Response to Highways Comments

Hinckley & District General Hospital, Mount Road

Project Number: 23013
Doc Number: TN02
Prepared for: NHS Properties

16 November 2023

Figure 3.1 Scope of Search

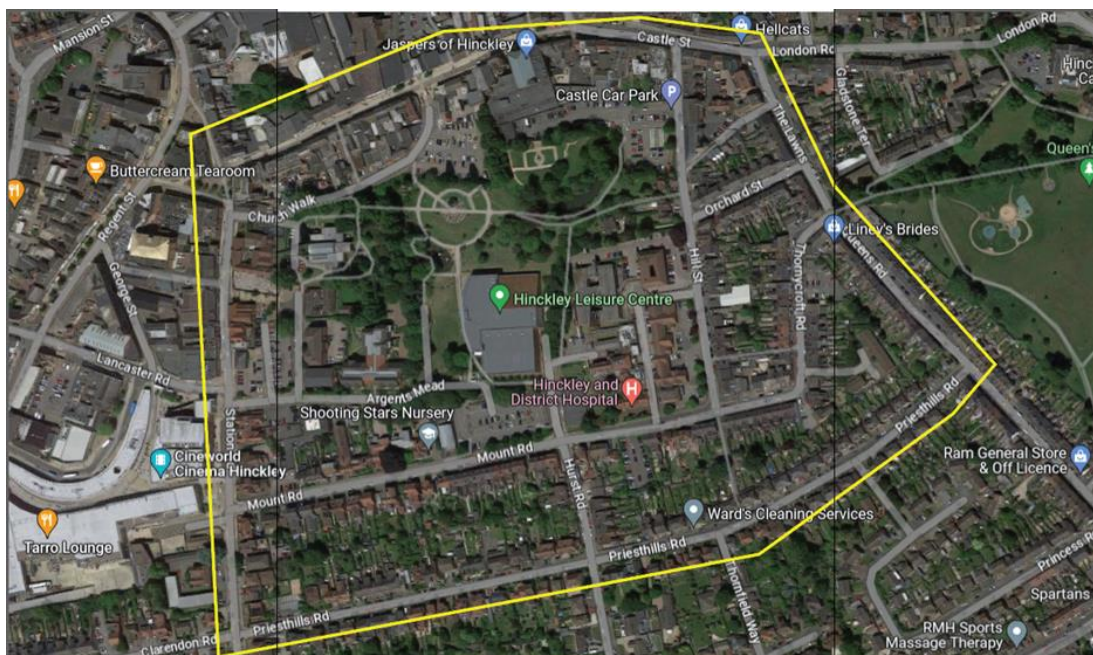
The Applicant states analysis of Personal Injury Collision (PIC) data for the surrounding highway network is pending at the time of writing. The LHA advises that this information is therefore still required. It is suggested the analysis considers PIC's along Mount Road and Hill Street. PIC data can be obtained from NDI@leics.gov.uk if necessary.

3.1 A PIA collision data search was commissioned from LCC, which included all roads within the vicinity of the hospital. Including Hill Street, Mount Road, Argents Mead, Hurst Road, Castle Street, Station Road, Priesthills Road, Orchard Street, The Lawns, and Queen's Road, which are the roads which would be expected to carry the distribution of site traffic in the first instance. The scope of search is shown overleaf in Figure 3.1.

3.2 The search returned a total of 5 recorded collisions, which are shown diagrammatically overleaf in Figure 3.2.

- 3.4 As shown, there were no recorded collisions in the area in 2022 or so far in 2023. Four of the recorded collisions resulted in slight personal injury casualties and the final collision in a serious injury.
- 3.5 All of the collisions occurred in dry conditions, and none involved a turning movement. Three collisions resulted in pedestrian injuries, including the serious casualty.
- 3.6 No factors are noted as potential causes for any collision; however, some appear to have been rear end shunts in slow moving traffic. The pedestrian movements are also not noted. However, there is no clear pattern of accident to suggest that there is a material design issue on any part of the local highway near to the site, and that the accident rate is low.
